WISSMAN TRACT

84.18 ACRE TRACT
MASTER DEVELOPMENT PLAN

City of San Antonio, Texas

Re: Wissman 323.91 Acre Tract Subdivision **MDP # 777-B (Amended)**

SHEET C1.00

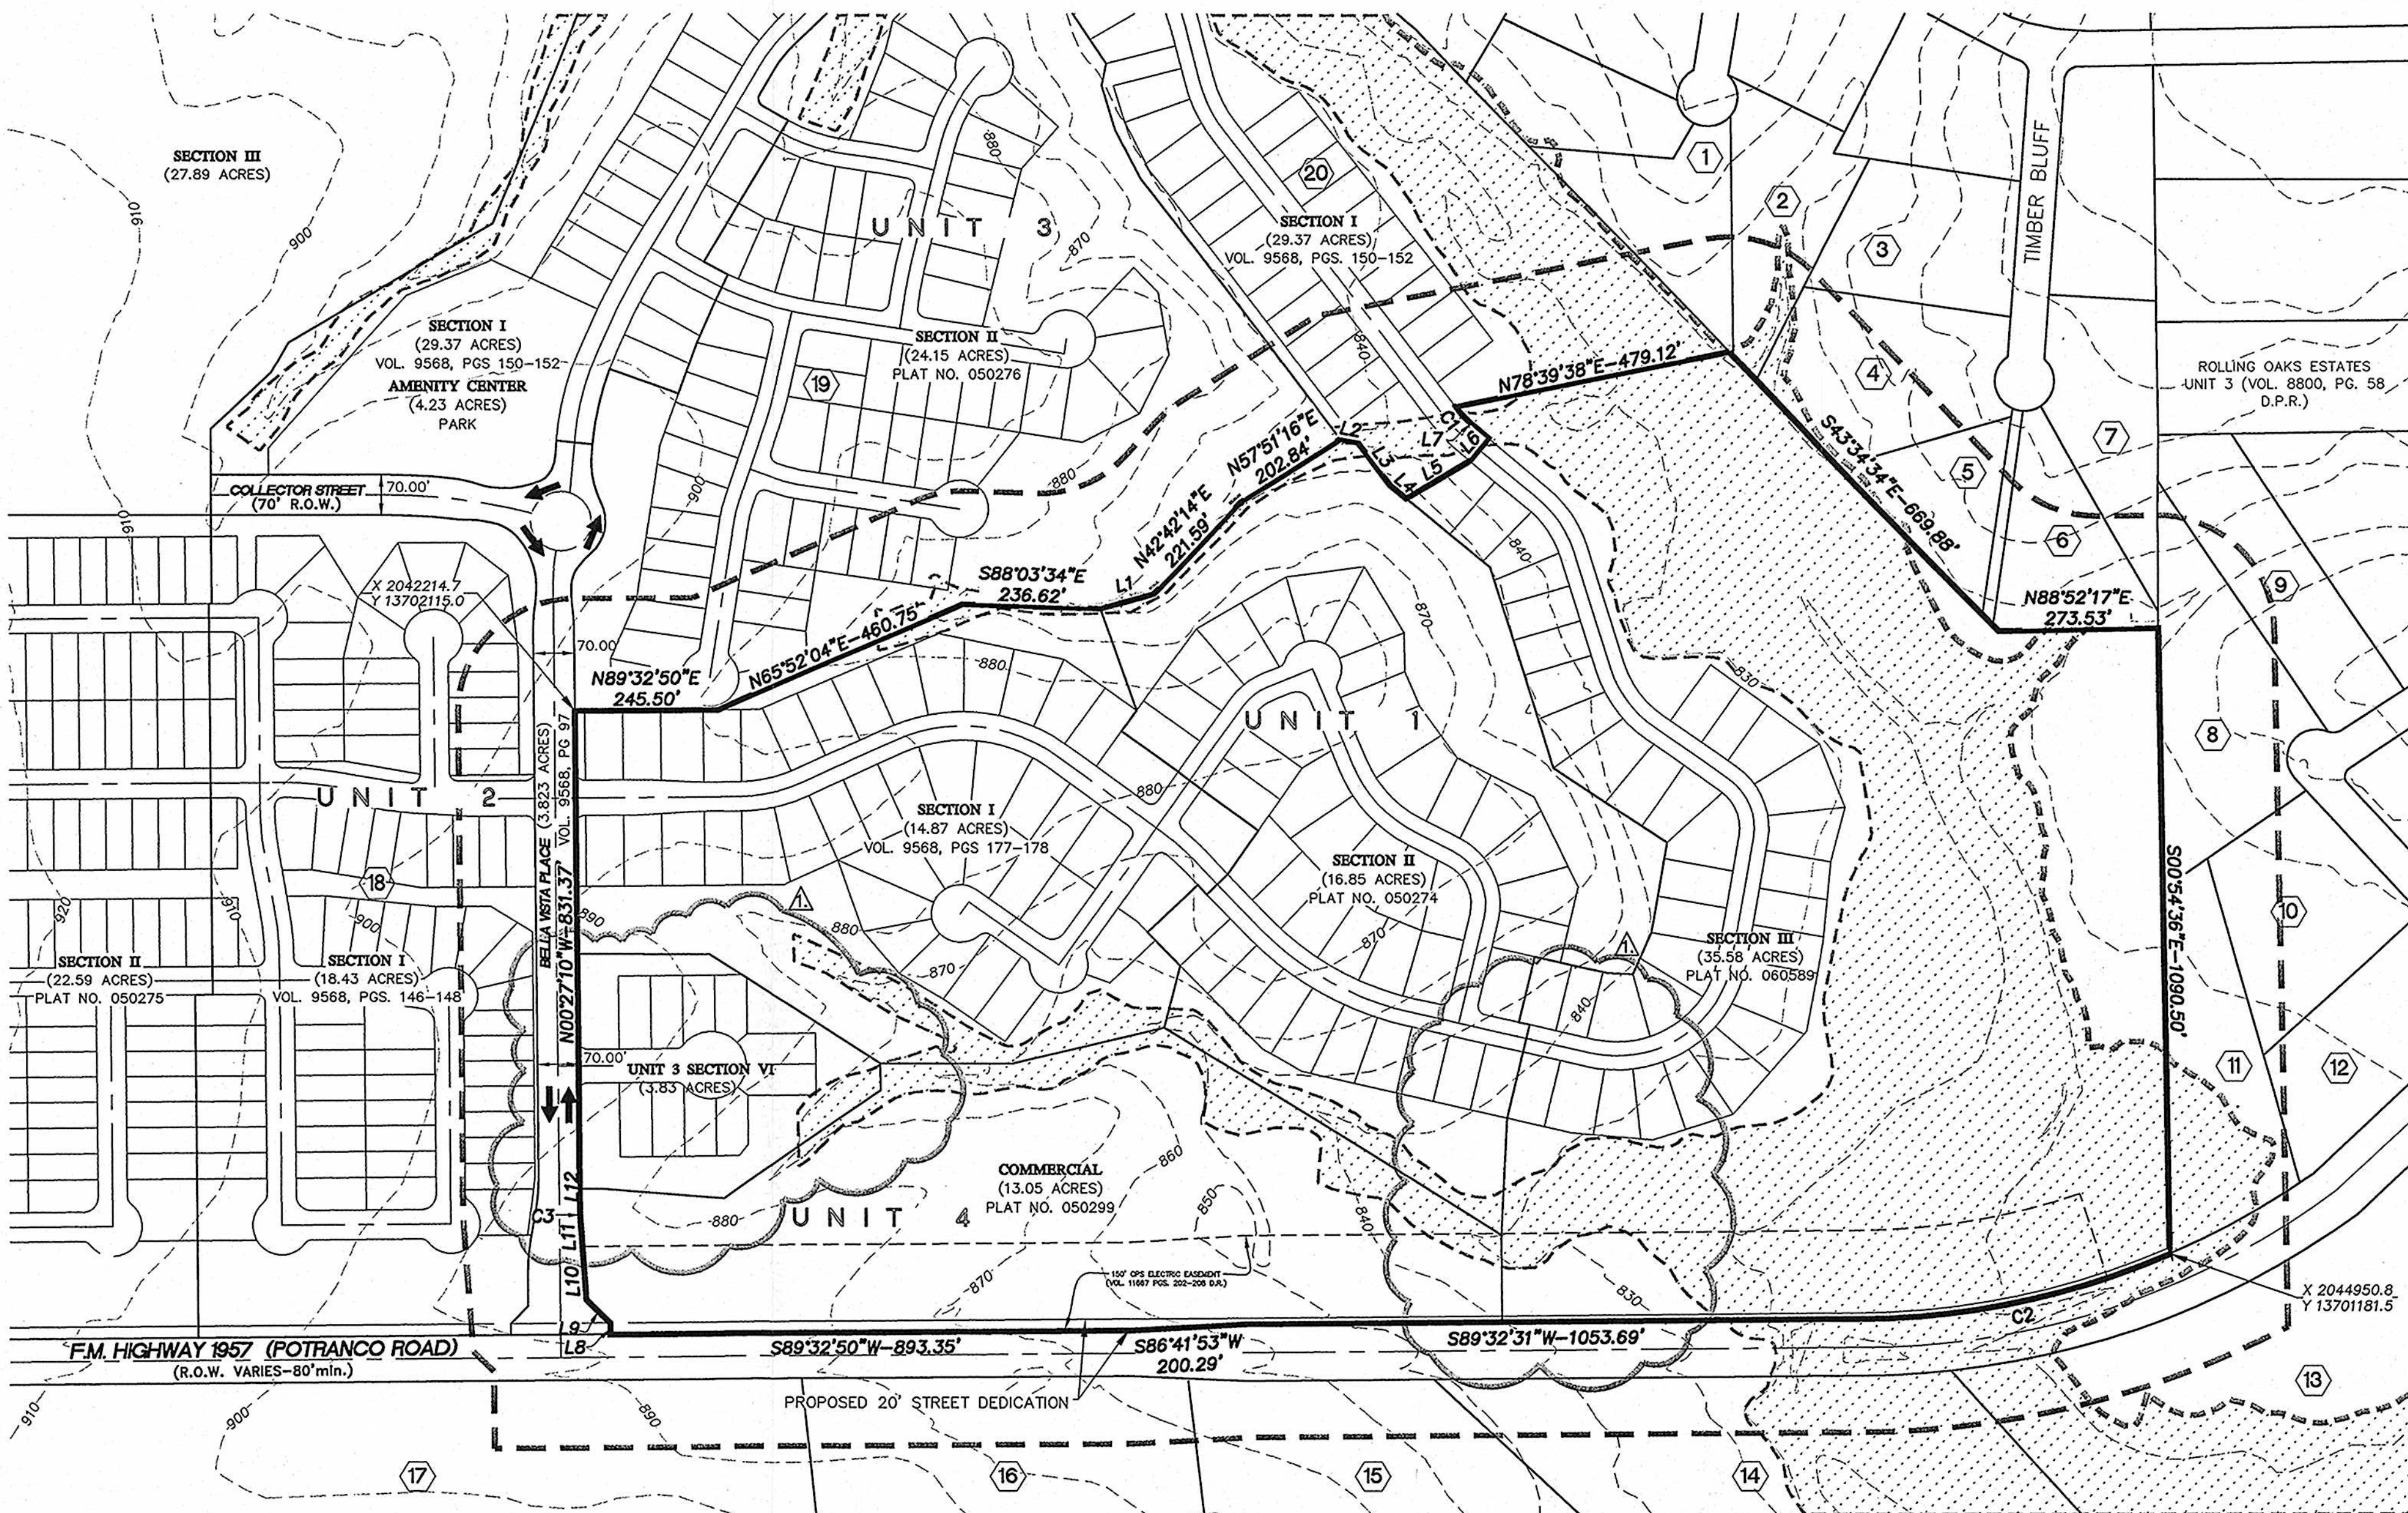
In consideration of public safety and convenience, excessive grades by reason of topography should be avoided in street layouts and arrangements.

Any access and R.O.W. issues along state facilities will need to be resolved with the **Texas Department of Transportation (TXDOT)**. For information about these requirements you can contact TXDOT at 615-5814.

It will be expected that you will plat all of the property depicted in your Master Development Plan (MDP) to include floodplains, drainage areas and open space.

- 2003 Tree Preservation ordinance standards per Sec. 35-523 of the Unified Development Code (UDC) – a Tree Permit is required prior to any work on site. This can be submitted either as a clearing permit at platting or building permit stage. Additional permitting fees and affidavits will be needed to obtain tree permits.

- The Parks Development Plan Amendment fee of \$260.00 has not been paid and must be paid prior to final acceptance of this plan.
- The parkland provided shall be shown as "Park" or "Open Space" on a plat per Sec. 35-503(e) *Designation of Parkland* of the UDC.
- The parkland provided shall be dedicated to the Home Owners Association.

- The instruments creating the Home Owners Association shall be provided by the second application for plat approval per Sec. 35-503(e) *Designation of Parkland* of the UDC.
- Parkland dedication shall be platted by the second phase of residential development per Sec. 35-503(f) *Development Phasing* of the UDC.
- All amenities provided shall comply with standards and specifications found in per Sec. 35-503(h) *Credit for Park Facilities* of the UDC and Table 503-4 of the UDC if any credit is to be awarded.

- It is understood that this MDP is a conceptual plan and all regulations will be addressed at time of platting.
- County reserves the right to address driveways, street design, sight distance, ADA requirements, drainage and floodplain issues at time of platting.
- All traffic control improvements shall conform to the Texas Manual on Uniform Traffic Control Devices.
- Roadway configurations adjacent to and within this development shall be consistent with the recommendations set forth in the Stevens Ranch Traffic Impact Analysis dated November 2003.
